MAGNOLIA SPRINGS SUBDIVISION

PHASE ONE

The plat illustrates the proposed 172-lot, 88.1± Acres, Phase One of Magnolia Springs Subdivision, which is located on the North side of Silver Pine Road, ½ mile ± West of Schillinger Road North, and is outside the city limits, but within the Planning Jurisdiction. The subdivision is served by public water and sanitary facilities.

DETAIL SITE PLAN

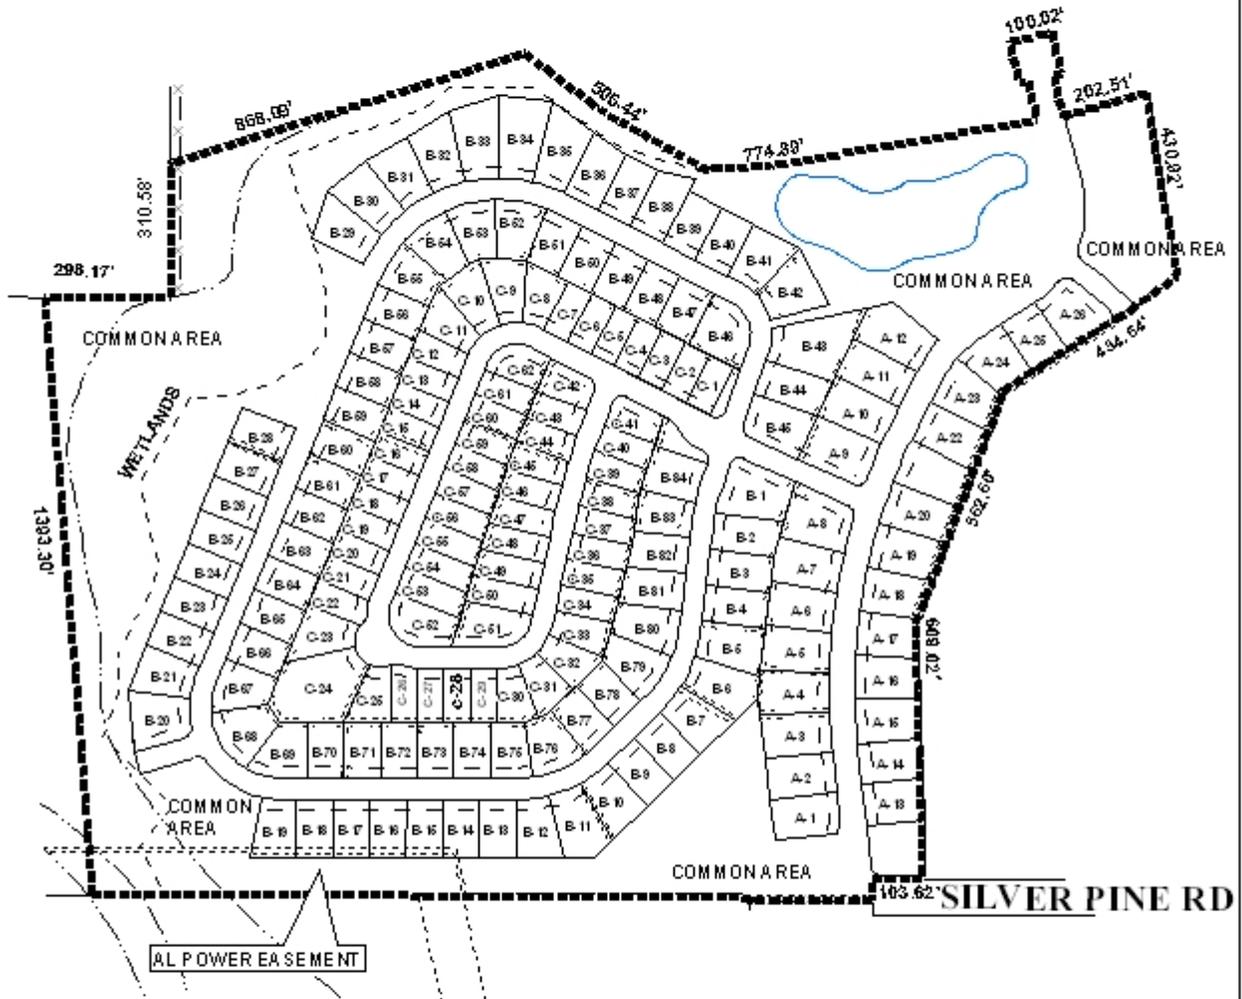
The new roads for the site are to be dedicated and constructed to meet County Engineering Standards. Additionally, since Lots A-8, A-9, A-26, B-1, B-20, B-45, B-46, C-41, C-42, C-51, C-52 and C-62 are corner lots, a note should be placed on the Final Plat stating that these are limited to one curb-cut each with the size, design and located to be determined by County Engineering.

The areas of open space are labeled as common area, as are areas of wetlands, islands or medians in the roadway, areas containing lakes and other amenities, as well as detention areas. All areas not designated as lots should be labeled as common areas, and a note should be required on the final plat, if approved, stating that maintenance of all common areas is the responsibility of the property owners (association).

This site is located in Mobile County, thus a note should be placed on the final plat stating that any lots which are developed commercially (or multi-family residential) and adjoin residentially developed property must provide a buffer, in compliance with Section V.A.7. of the Subdivision Regulations.

While the site is in the County, the applicant's engineer will be required to certify that the stormwater detention, drainage facilities, and release rate comply with the City of Mobile

stormwater and flood control ordinances, prior to the signing and recording of the final plat, if approved. The plat should also be revised to depict lot sizes to be illustrated in square feet either through labeling or the provision of a table on the Final Plat.

1. dedication of sufficient right-of-way along Silver Pine Road to provide 50' from centerline for the portion on the Major Street Plan, and 30' from centerline for the remainder of the future frontage, as shown on the plat submitted;

2. the placement of a note on the Final Plat stating that A-8, A-9, A-26, B-1, B-20, B-45, B-46, C-41, C-42, C-51, C-52 and C-62 are corner lots, are limited to one curb cut, with the size, design and location to be determined by County Engineering;

4. all proposed roads be constructed to county standards, and dedicated to Mobile County;
5. all areas not designated as lots should be labeled as common areas (including wetlands and detention areas), and a note placed on the final plat stating that maintenance of all common areas is the responsibility of the property owners (association);

6. placement of a note on the final plat stating that any lots which are developed commercially (or multi-family residential) and adjoin residentially developed property must provide a buffer, in compliance with Section V.A.7. of the Subdivision Regulations;

7. provision of a certification letter from a licensed engineer to the Planning Section of Urban Development, certifying that the stormwater detention, drainage facilities, and release rate comply with the City of Mobile stormwater and flood control ordinances, prior to the signing and recording of the final plat; and

8. labeling of all lots with size in square feet, or placement of a table on the plat containing the lot size information.
